SUNDRY NOTICES AND REPORTS ON WELLS
Do not use this form for proposals to drill or to re-enter an abandoned well. Use Form 3160-3 (APD) for such proposals.

Black Hills Gas Resources intends to plug and abandon Jicarilla 531 #1 per attached procedure dated 4/7/11.

PLUG AND ABANDONMENT PROCEDURE

CONDITIONS OF APPROVAL

Proposed P&A

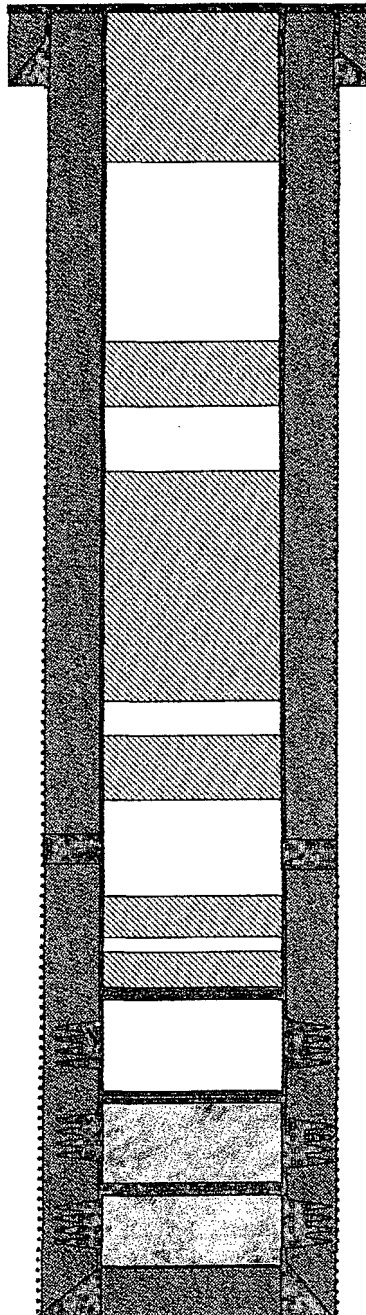
Notify NMOCD 24 hrs
prior to beginning
operations

Please Submit Recent CBL before plugging

1. Plugging operations authorized are subject to the attached "General Requirements for Permanent Abandonment of Wells on Federal and Indian Lease."
2. Farmington Office is to be notified at least 24 hours before the plugging operations commence (505) 599-8907.
3. The following modifications to your plugging program are to be made:
 - a) Place the Mesaverde plug from 5888' – 5788'.
 - b) Place the Pictured Cliffs plug from 3530' – 3430'.
 - c) Place the Nacimiento plug from 1728' – 1628'.

You are also required to place cement excesses per 4.2 and 4.4 of the attached General Requirements.

5888 5788
5. **Plug #2 (Mesaverde top, 5760' – ~~5660'~~)**: Spot 17 sxs Class B cement inside casing to cover the Mesaverde top. PUH.

3530 3430
6. **Plug #3 (Pictured Cliffs top, ~~3880'~~ – 3780')**: Spot 17 sxs Class B cement inside casing to cover the Pictured Cliffs top. PUH.
7. **Plug #4 (Fruitland, Kirtland and Ojo Alamo tops, 3410' – 2854')**: Spot 69 sxs Class B cement inside casing to cover through the Ojo Alamo top. PUH.
8. **Plug #5 (Nacimiento top, ~~1701'~~ – ~~1601'~~)**: Spot 17 sxs Class B cement inside casing to cover through the Nacimiento top. PUH.

1728 1628
9. **Plug # 6 (Surface casing shoe, 368' – Surface)**: Attempt to pressure test the bradenhead annulus to 300 PSI; note the volume to load. If the BH annulus holds pressure, then establish circulation out casing valve with water. Mix approximately 50 sxs cement and spot a balanced plug from 368' to surface, circulate good cement out casing valve. TOH and LD tubing. Shut well in and WOC. If the BH annulus does not test, then perforate at the appropriate depth and attempt to circulate cement to
